**Re: Huntington Beach Energy Project (12-AFC-02)**  
**Applicant's Supplemental Data Response to Data Request #68 (Visual)**

# Supplemental Data Response to Visual Resources DR68

Telephone call from Jeanine Hinde, California Energy Commission, to Thomas Priestley, CH2M HILL, on November 16, 2012 (1:00 PM), regarding questions she had related to Figures 5.13-1a R1 and 5.13-1b R1 that were submitted in response to Data Request 68 (part of Data Response Set 1a) docketed on November 2, 2012.

**Figure DR68-1  
Location of Viewpoint 1**

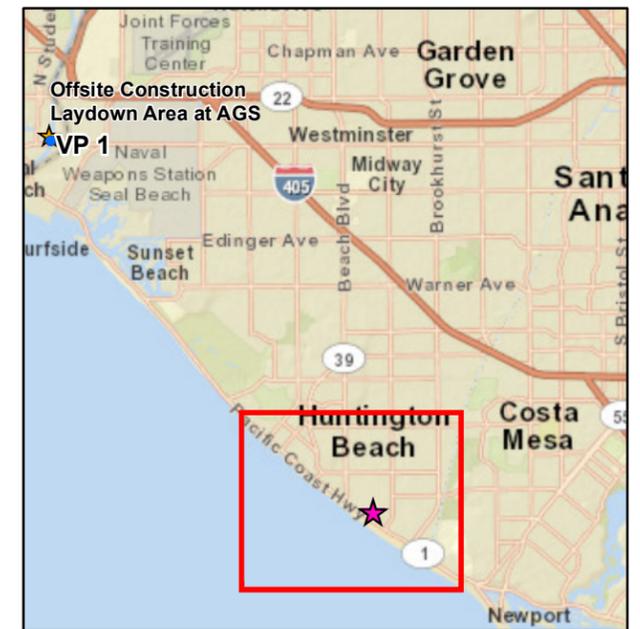
2. In reviewing these two map figures, the location of Viewpoint 1, the point from which the photo of the view toward the proposed parking area at the Alamitos Generating Station had been taken, was difficult to find. This viewpoint was shown on both figures on a small inset map. Ms. Hinde indicated that these small inset maps did not provide her with the information she needed to understand the location of this viewpoint and its relationship to its surroundings, and that she would like a map figure that zooms in on this location to show it in more detail. Additionally, on Figures 5.13-1a R1 and 5.13-1b R1, the labeling of the arrows for Viewpoint 2 and KOP 4 appeared to have been reversed.

A new figure, Figure DR68-1, which is a map on an air photo base, has been prepared to provide a close-up of the location from Viewpoint 1, the point from which the photo was taken that was used in the AFC (Figure 5.13-2) to depict the view of the area on the Alamitos Generating Station site that will be used for construction parking.

**FIGURE 5.13-1a R2**  
**Project Site and Locations of Viewpoints and KOPs**  
 AES Huntington Beach Energy Project  
 Huntington Beach, California

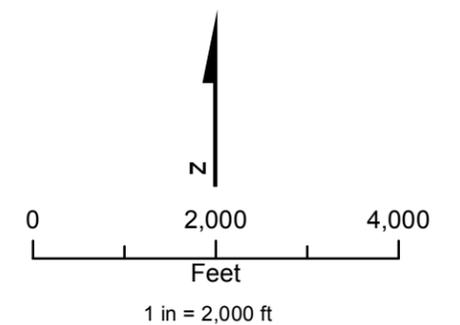
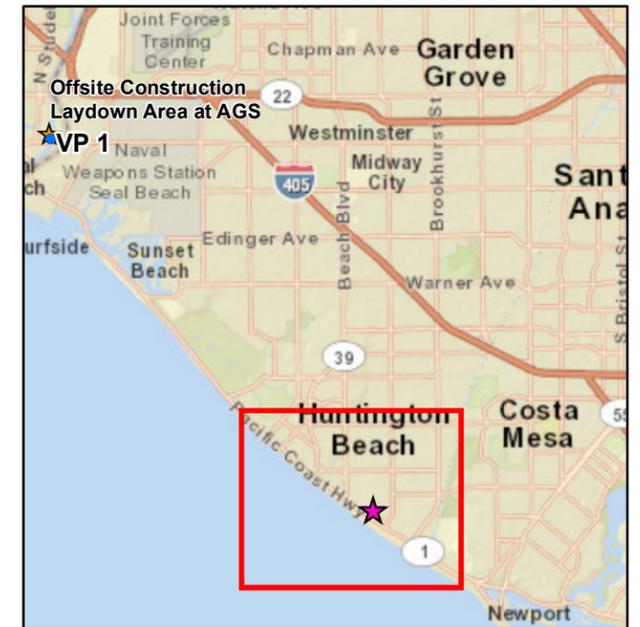
Jeannine also pointed out that on Figures 5.13-1a R1 and 5.13-1b R1, the labeling of the arrows for Viewpoint 2 and KOP 4 appeared to have been reversed. I confirmed that she was correct in this assessment and indicated that we would provide her with revised versions of the two figures on which this error had been corrected.

Figures 5.13-1a R1 and 5.13-1b R1 have been modified to correct the labeling of the arrows for Viewpoint 2 and KOP 4, which were inadvertently reversed in the original responses. The revised figures are attached as Figures 5.13-1a R2 and 5.13-1b R2.
